September 22, 2010

Reference No. 14027-14

Re: Response to August 12, 2010 U.S. EPA letter
Legacy Site Services, LLC - East Plant
Riverview/Wyandotte, Michigan

NAPL OBSERVATIONS
HALOWAX AREA

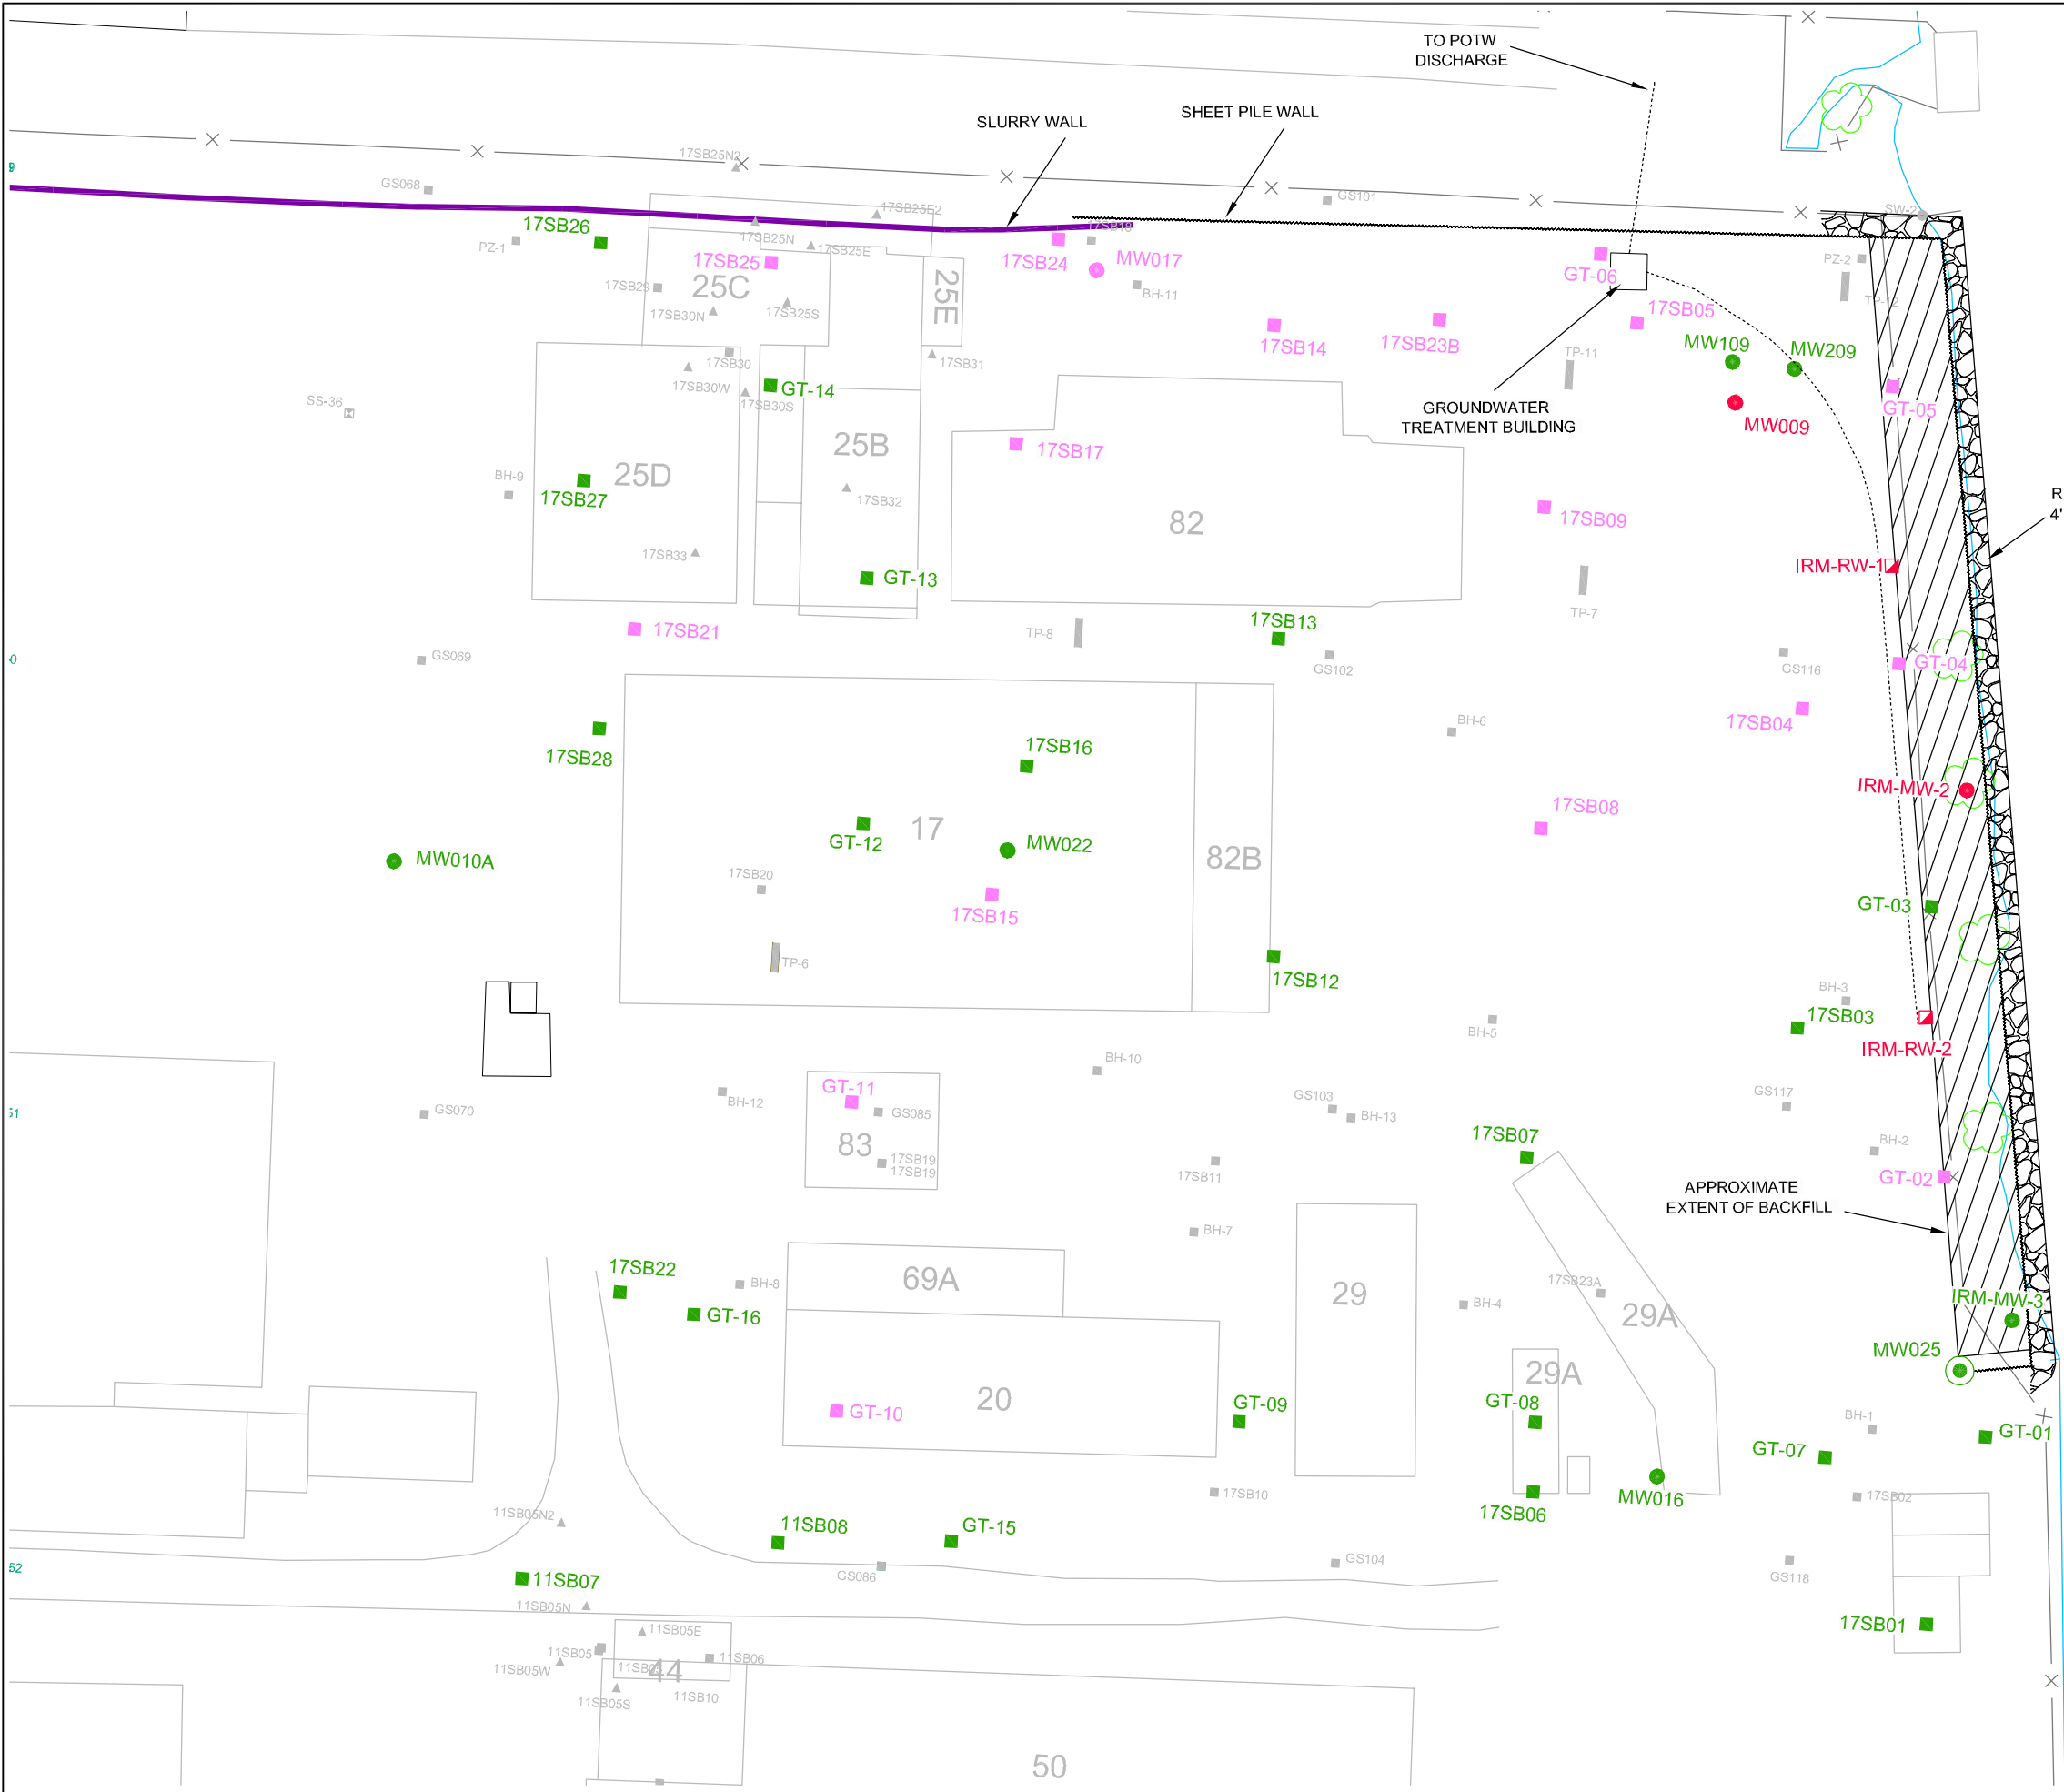
- 2) **DNAPL Extent Figure** - U.S. EPA indicated that the RCRA Facility Investigation (RFI) Report Figure 2.1 appeared to depict DNAPL extent but that a better extent figure was preferred, if available.

In response to this comment, CRA created a figure depicting observations pertaining to potential NAPL in the Halowax Area. The figure, provided as Attachment B, depicts results of a review of over 50 soil boring logs (all of the boring logs reviewed are included in the RFI Report, Appendix C). Color coding is utilized on the figure to show where soil boring log descriptions and/or monitoring well measurements do not indicate the presence of NAPL; where potential NAPL was observed in soil boring logs; and where NAPL has been physically measured in existing wells. Borings colored to indicate potential NAPL are generally locations where staining, odors or other potential NAPL indicators were observed

on the boring logs (oil/sheen/product references), but it is important to note that measurable free product has not been confirmed at those locations.

As shown on the figure, data suggests that there is not a contiguous DNAPL plume in Area 17. DNAPL appears at relatively isolated locations mainly in the northeastern quadrant of the area.

It is important to note that Figure 2.1 of the RFI is a Site Plan, depicting Solid Waste Management Unit (SWMU) boundaries; it is not a DNAPL extent Figure. A DNAPL extent figure was not created as part of the RFI or CMS reports as the IRM located in Area 17 (the "Hallowax Area") encompasses the area in which DNAPL has been identified and has been effective at controlling risks in the area. As mentioned in the CMS Report, the IRM consists of containment, recovery and treatment elements, which are collectively:
